UNITED STATES PATENT AND TRADEMARK OFFICE

APPLICATION NO.	FILING DATE	FIRST NAMED INVENTOR	ATTORNEY DOCKET NO.	CONFIRMATION NO.
10/708,515	03/09/2004	Ronald L. Gordon	FIS920030380	2514
29505 7590 02/14/2008 LAW OFFICE OF DELIO & PETERSON, LLC. 121 WHITNEY AVENUE NEW HAVEN, CT 06510			EXAMINER RASHID, DAVID	
			ART UNIT 2624	PAPER NUMBER
			MAIL DATE 02/14/2008	DELIVERY MODE PAPER

Office Action Summary

DETAILED ACTION

FIG. II

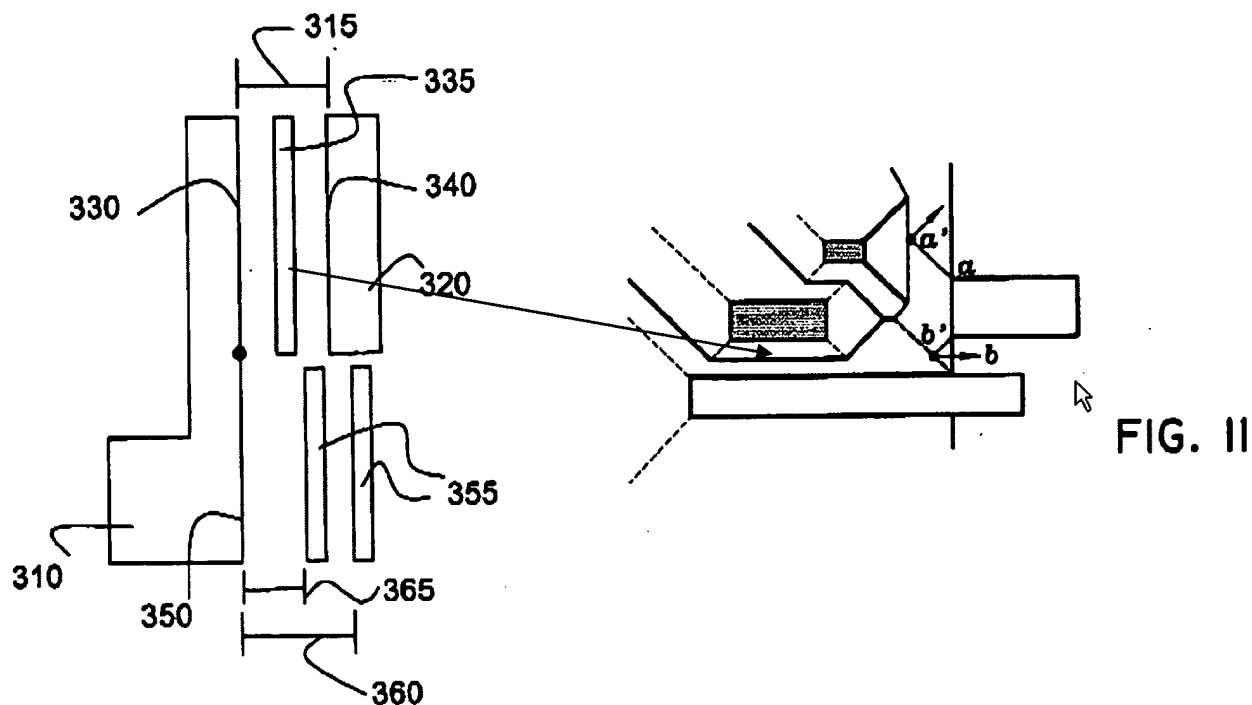
However, Robles makes no mention of every bisector or SRAF that cannot extend beyond its features which enables an operable combination when using the bisectors from the Voronoi cells of Papadopoulou (which do in fact extend beyond its features). Papadopoulou does in fact remedy the deficiencies of Robles. On much broader reasoning, the Examiner asserts that it would have been obvious to develop another bisector algorithm (such as using Voronoi cells as taught by Papadopoulou) within the objective of Robles for creating a photomask. SRAFs need a bisector algorithm to be placed onto the photomask, and it would have been obvious to use the Voronoi cells of Papadopoulou to do so. In specific, FIG. 11 of Papadopoulou shows such a bisector between two integrated circuit shapes that extends beyond the integrated circuit shapes. It would have been obvious to one of ordinary skill in the art at the time the invention was made for place an SRAF on top of this bisector, which would ultimately be an SRAF that extends beyond an adjacent spaced integrated circuit shape. This combination is entirely operable in view of the broadness of the claims in question.

It would have been obvious to one of ordinary skill in the art at the time the invention was made

(i) for the method of Robles to include creating Voronoi cells around the spaced integrated circuit shapes as taught by Papadopoulos;

(ii) for the bisectors at predetermined distances of Robles to be the bisectors determined from the Voronoi cells as taught by Papadopoulos; and

(iii) for the SRAFs of Robles to be placed on the Voronoi cell bisectors of Papadopoulos in such a way as to extend beyond an adjacent integrated circuit shape (as the Voronoi cells already extend beyond the integrated circuit shapes) as “[t]he present disclosure further describes a method for speeding up the grid method of Wagner and Koren, in the above referenced article. The method is based on a low polynomial algorithm to compute critical area for shorts accurately in irregular rectilinear layouts.”, Papadopoulos, Col. 5, lines 14 – 19 and that “[t]he method is presented for rectilinear layouts but it is extendible to general layouts.”, Papadopoulos, Col. 5, lines 13 – 14 and
